Your Ref: 21/00205/FUL

RE: PROPOSED URBAN RESERVE ENERGY STORAGE FACILITY, MIALL POWER, LAND ON THE NORTH EAST SIDE OF RICHARD STREET, ROCHDALE, 0L11 1BU

Figure 1: Assessment of Alternative Site Locations

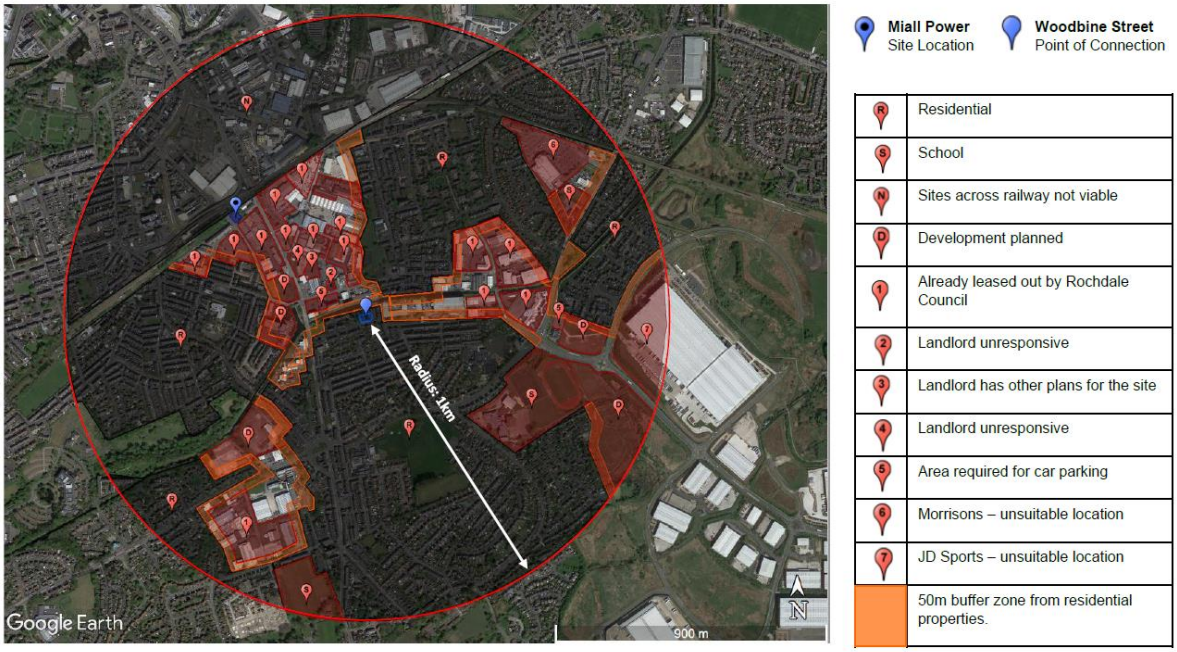
The Miall Power Energy Storage Facility (ESF) site was selected for a number of reasons on the land on the north east side of Richard Street. Electricity North West have provided the applicant AMP Energy Services Ltd. (AMP) with a point of connection (POC) at Woodbine Street substation for the ESF which can been seen on Figure 1 below. Due to the significant expense of high voltage cabling, the site must be located within a 1km radius of the POC to be financially viable. The railway line running across the north east sector of this area is a physical barrier to new electrical connections, rendering all land beyond unviable.

A large proportion of the remaining land is either residential (R), under development (D) or already leased by Rochdale Borough Council to other businesses (1). This leaves very few alternative site locations, all of which have been ruled out due to proximity to residences or with thorough investigation.

If our application were to be rejected due to the site location, there is no alternative land in this region upon which to develop this project. We would therefore not be able to provide network support and security of supply to the local area along with other net zero benefits.
